**ZONING BOARD OF APPEALS
Regular Meeting Agenda
Wednesday July 2, 2025
6:30 P.M.**

Zoning Board of Appeals Staff Report

Action Requested: Request for variance to the lighting requirements outlined in Article 13 – Section 1303.3 (A & B)

EXTERIOR LIGHTING PROGRAM

SHEET NO. LU-4

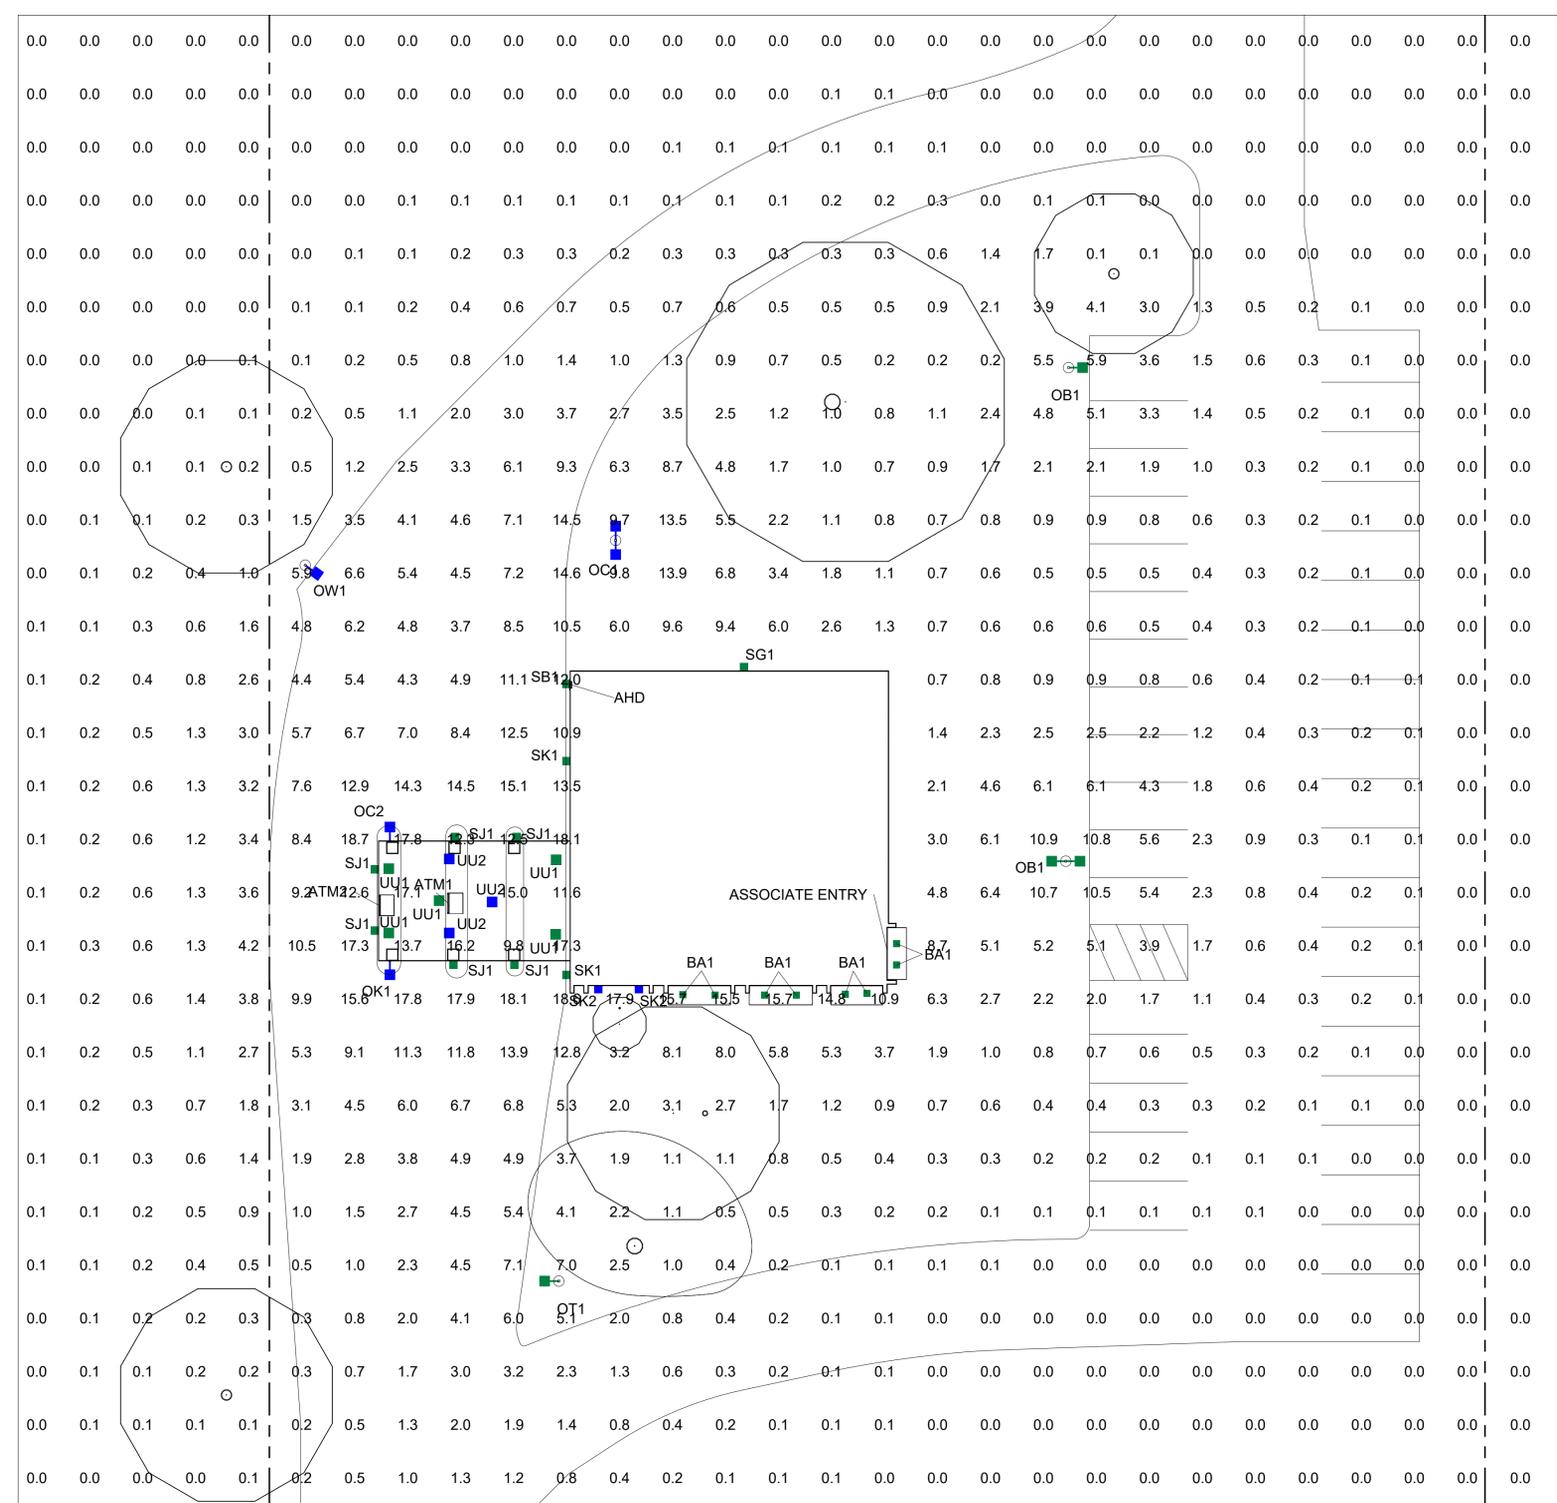
Lighting Regulation	Permitted Level	Submitted Plans	Variance Required
Maximum illumination at ground level along the western property line (adjacent to residential property)	0.5 footcandles	0.0 to 4.2 footcandles (See Sheet LU-4)	Up to 4.2 footcandles above the permitted level

The previous set of plans proposed lighting levels along the western property line, ranging from 0.0 to 13.5 footcandles. However, the revised plans (Sheet LU-4) propose lighting levels along this property line between 0.0 to 4.2 footcandles. Also, light levels fade to

almost zero approximately 35 feet from the property line. The residential structure is approximately 210 feet from the property line. For these reasons, we don't consider the variance to be a substantial detriment to the adjacent property, nor will it alter the character of the area.

3. The maximum lighting levels at the property line are 4.2 footcandles, but they fade to almost zero approximately 35 feet into the residentially-used property. The residential building is approximately 210 feet from the property line. It is unlikely that the proposed light levels will negatively impact the residential use of the neighboring property.
